Project	IEEE 802.16 Broadband Wireless Access Working Group < http://ieee802.org/16 >	
Title	Support of Long Data in Extended IE	
Date Submitted	2005-01-17	
Source(s)	Geunhwi Lim, Yong Chang Samsung Electronics Co. Ltd.	geunhwi.lim@samsung.com
Re:		
Abstract	Extended IE fragmentation scheme	
Purpose	Adoption of proposed changes into P802.16e /D5-2004	
Notice	This document has been prepared to assist IEEE 802.16. It is offered as a basis for discussion and is not binding on the contributing individual(s) or organization(s). The material in this document is subject to change in form and content after further study. The contributor(s) reserve(s) the right to add, amend or withdraw material contained herein.	
Release	The contributor grants a free, irrevocable license to the IEEE to incorporate material contained in this contribution, and any modifications thereof, in the creation of an IEEE Standards publication; to copyright in the IEEE's name any IEEE Standards publication even though it may include portions of this contribution; and at the IEEE's sole discretion to permit others to reproduce in whole or in part the resulting IEEE Standards publication. The contributor also acknowled

Figure 1 Fragmentation of long payload in Extended IE

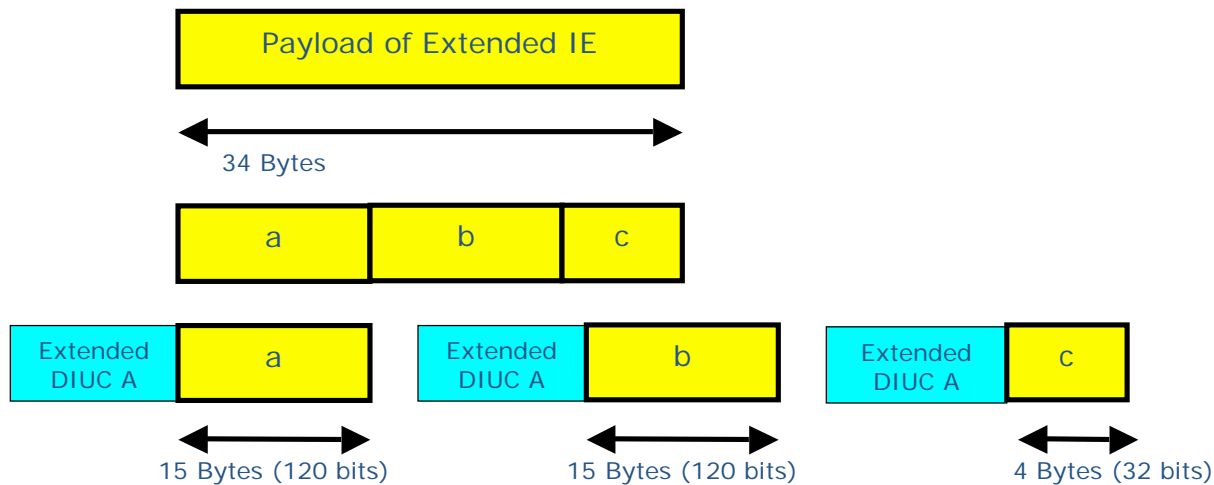
When the size of payload exceeds 15 Bytes, the payload shall be divided into several fragmented payloads which has a size of 15 Bytes. Then each fragmented payload will have a Extended DIUC header with a same extended DIUC value.

This payload fragmentation mechanism is applied only on specific extended IE. And the IE which adopt the payload fragmentation shall specify that BS can apply payload fragmentation on it.

[For a some extended IE which have a fragmentable and variable size data, if the size of data is exceeds 15 Bytes, the data shall be divided into several fragmentation. Each fragmented data will have a Extended DIUC](#)

header with a same extended DIUC value. This data fragmentation mechanism shall be applied only on specific extended IE. And the IE which adopt the payload fragmentation shall specify that BS can apply payload fragmentation on it.

When a MSS finds sequential extended IE which is adopting the data fragmentation, MSS shall decode the data after it merge the data in each extended IE into one.
